## SUBDIVISION REVIEW SHEET

<u>CASE NO.</u>: C8-2013-0051.0A <u>P.C. DATE</u>: November 12, 2013

**SUBDIVISION NAME:** Raymond H. Stewart Lot B, Resubdivision

Re: Re-subdivision of Lot B, Raymond H. Stewart Subdivision - C8-2013-0051.0A

## RESUBDIVISION OF LOT B RAYMOND H. STEWART SUBDIVISION

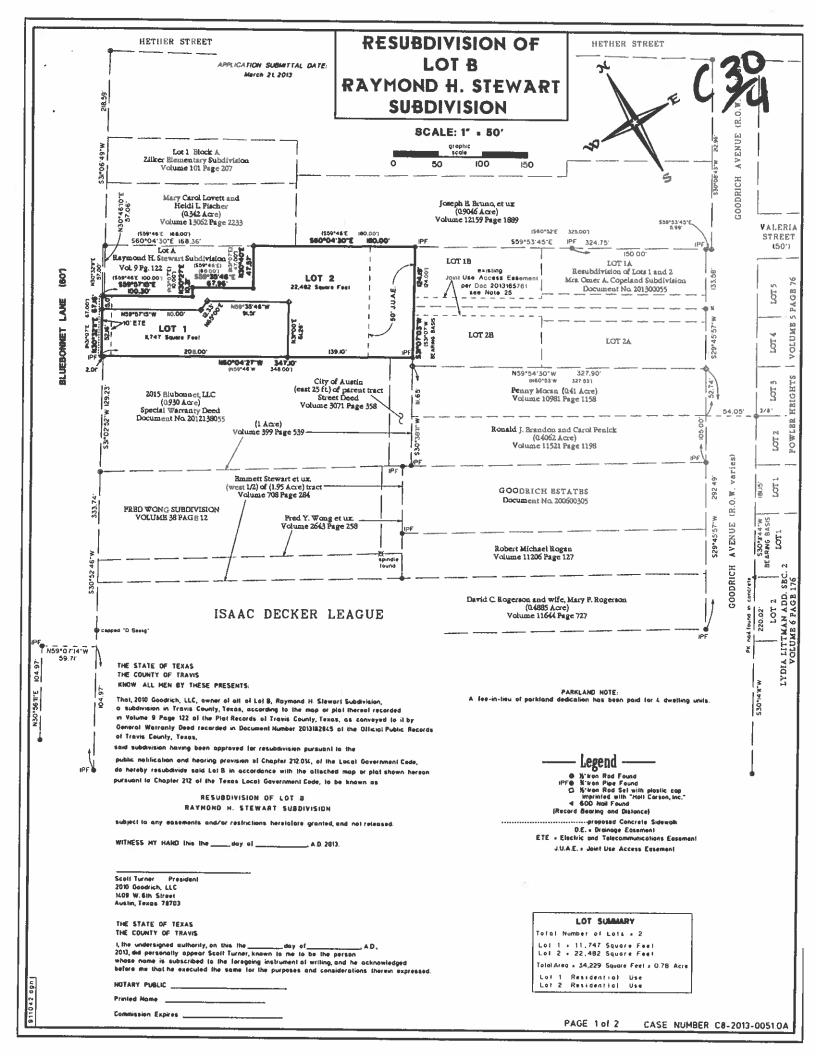
<u>VARIANCES</u>: A variance to L.D.C Section 25-4-175 to allow a residential flag lot has been requested. The applicant is proposing one residential flag lot with this application. The applicant has obtained approval from the Fire Department to verify accessibility for emergency responders, approval from the Austin Water Utility, Austin Energy, and the City Arborist to verify there is adequate room for the required utilities and enhanced tree protection on the site. The flag lot has a 15 feet width and follows requirements listed in Section 25-4-175(B)(2) minimum width of a flag lot. The flag lot is demonstrating access through an alternative route with access through Goodwin Avenue and restricted access to Bluebonnet Lane. A note has been included on the plat restricting access to Bluebonnet Lane.

It is the Staff's opinion that the proposed subdivision is compatible with the surrounding development, and is consistent with the flag lots on the adjacent lots to the east. It should also be noted that there are no known deed restrictions on the site, and a note has been added that requires all addresses for residential lots utilizing a flag lot design must be displayed at their closest point of access to a public street for emergency responders. Because the application meets the flag lot criteria as required by the Land Development Code, the Staff recommends approval of the variance.

**<u>DEPARTMENT COMMENTS</u>**: The applicant is proposing to resubdivide one lot into two lots on 0.78 acres. One of the proposed lots is a flag lot which requires a variance.

**STAFF RECOMMENDATION:** If the variance is approved, the staff recommends approval of the plat. With variance approval, this plat would meet all applicable State and City of Austin LDC requirements.
